Road Safety Audit Report Mossman – Mt Molloy Road

Project No: 29-2014

Stage 5 - Road Safety Audit Mossman – Mt Molloy Road

Date: July, 2014

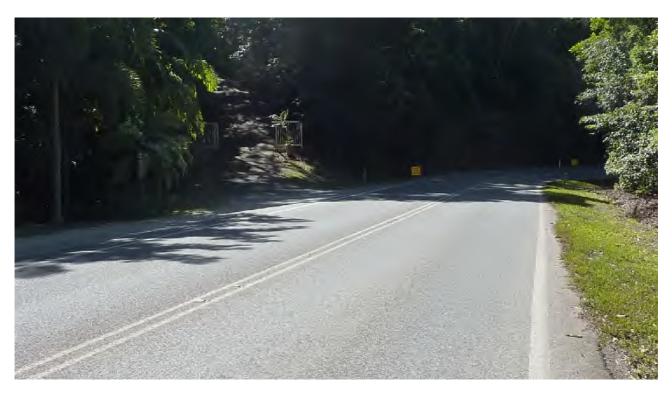
Restricted Sight Distances

Restricted Sight Distances

Restricted Sight Distance for RH Turning HV

Roadside Stall Access

Pavement Fatigue

Pavement Fatigue

Road Verge Damage

Road Verge Damage

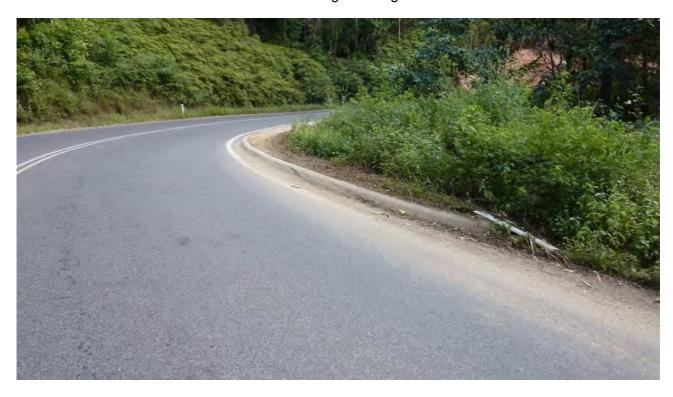
Road Verge Damage

Road Verge Damage

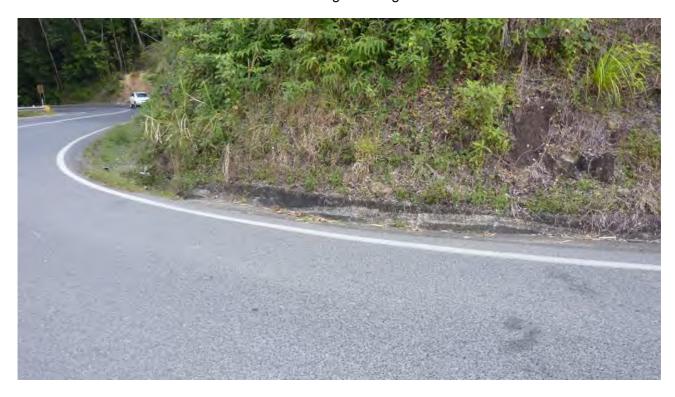
Road Verge Damage

Delineation – Terminal End Treatments Missing

Restricted width

Delineation – Terminal End Delineation Missing

Delineation – Terminal End Delineation Missing

Delineation – Terminal End Delineation Missing
